UNITED STATES PATENT AND TRADEMARK OFFICE

Office Action Summary

10/806,520

CHERUKURI ET AL.

FIG. 3A

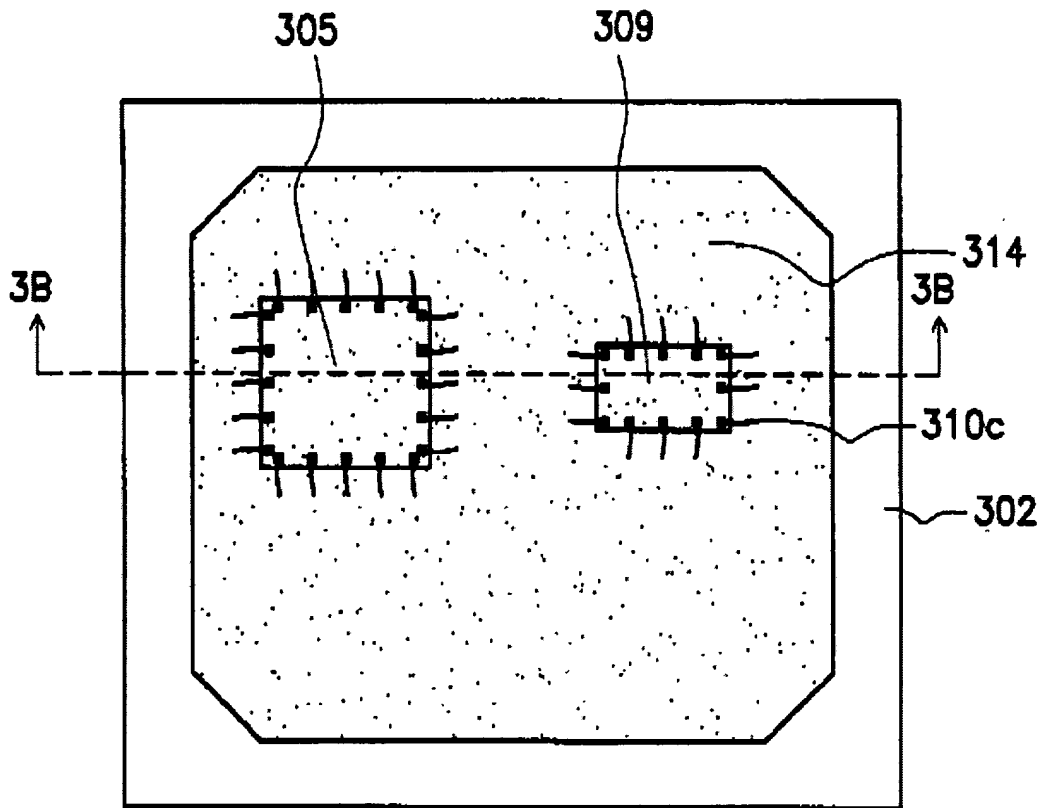
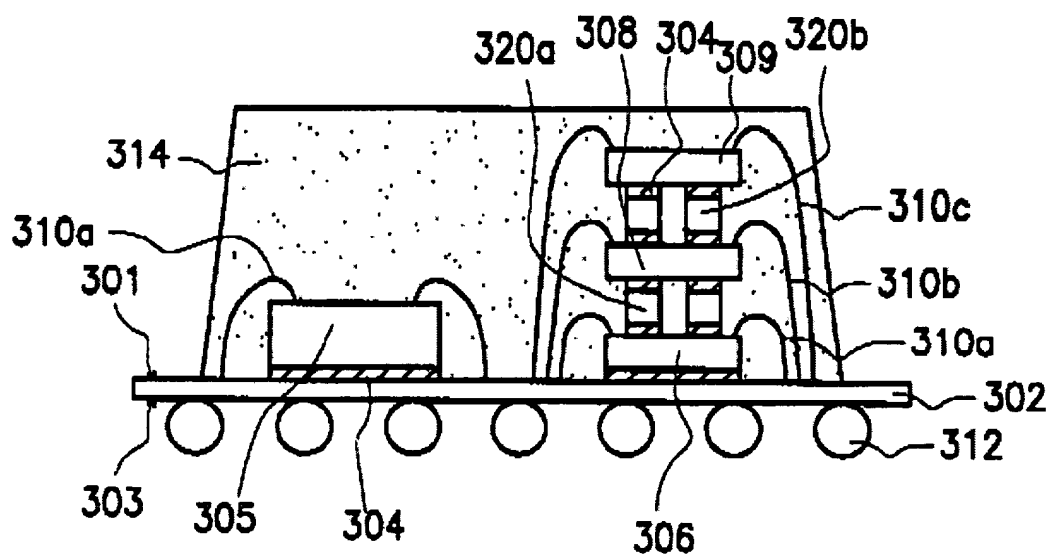
Her discloses (in the abstract, fig 3A,fig 3B) a semiconductor device comprising: a substrate (fig 3B,reference 302) having conductive interconnections; two or more vertically stacked chips on said substrate, each supporting chip having metal standoffs (fig 3B, reference 320a ,320b,column 4 lines 28-32) thereon to separate it from the next successive chip; and a plurality of bond wires connecting at least one chip to said substrate.

Her discloses (in the abstract, fig 3A,fig 3B,reference 320a,320b,column 4 lines 28-32)

A semiconductor device wherein the metal standoff are thermally conductive.

Her discloses (in the abstract, fig 3A,fig 3B,) a semiconductor device wherein the metal standoff are surrounded by bond pads.

Her discloses (in the abstract, fig 3A,fig 3B,) a semiconductor device wherein the bonds wires connect more than one chip to the substrate.

Her discloses (in the abstract, fig 3A,fig 3B,) a semiconductor device wherein the substrate is a BGA (Ball Grid Array) package substrate.

Her discloses (in the abstract, fig 3A,fig 3B) a semiconductor device wherein the metal standoffs have uniform height.

FIG. 5 PRIOR ART

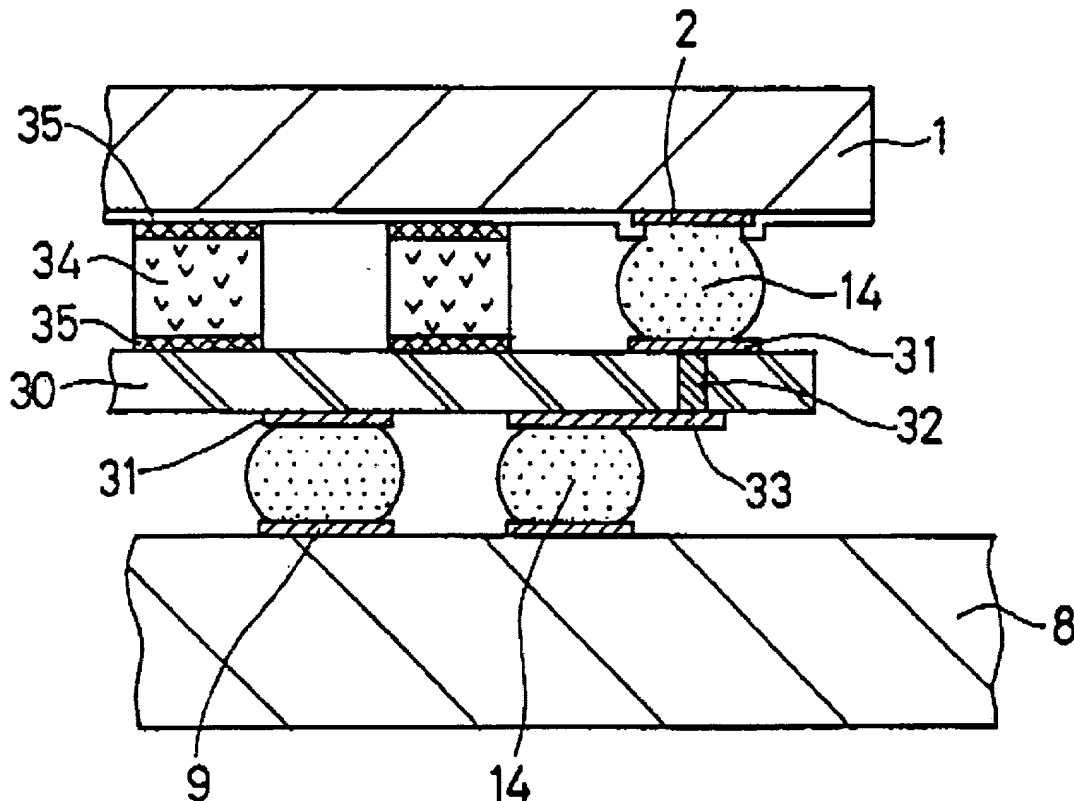
Her et al. (in the abstract, fig 3A,and fig 3B,column 4 lines 18-32) disclose all the invention including metallic islands standoff except for going into specific details that the metal standoff comprises aluminum islands. This feature, however, is considered obvious because the use of aluminum standoff is old and well known in the art. as evidenced by the disclosure by Baba (US patent 6,016,013 fig 5 and column 2 lines 1-4)

A person skilled in the art at the time the invention was made would be able to use the teachings by Her and his own routine design skill and come up with the invention of claim 2

FIG. 5

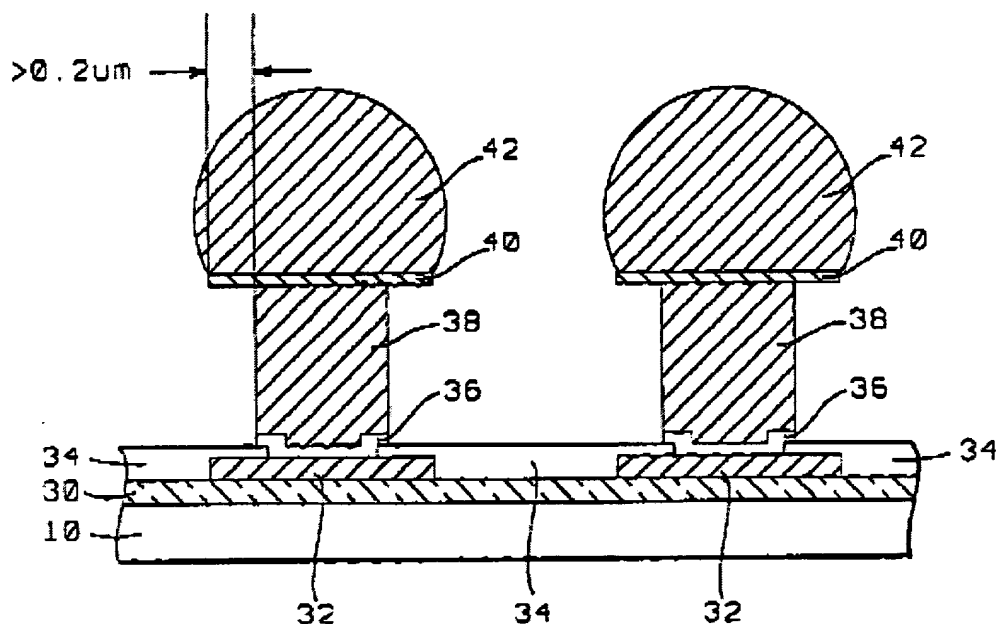
Her et al. (in the abstract, fig 3A, and fig 3B, column 4 lines 18-32) disclose all the invention except going into detail about a passivation layer on top of a substrate.

This feature, however, is considered obvious since the use of a passivation layer on top of a substrate is old and well known in the art as evidenced by the disclosure by Lee et al. (US patent 6,818,545) in fig 5, in column 6 lines 30-36.

The rationale why claim 4 is obvious over Her et al. has been discussed in the rejection of claim 2.
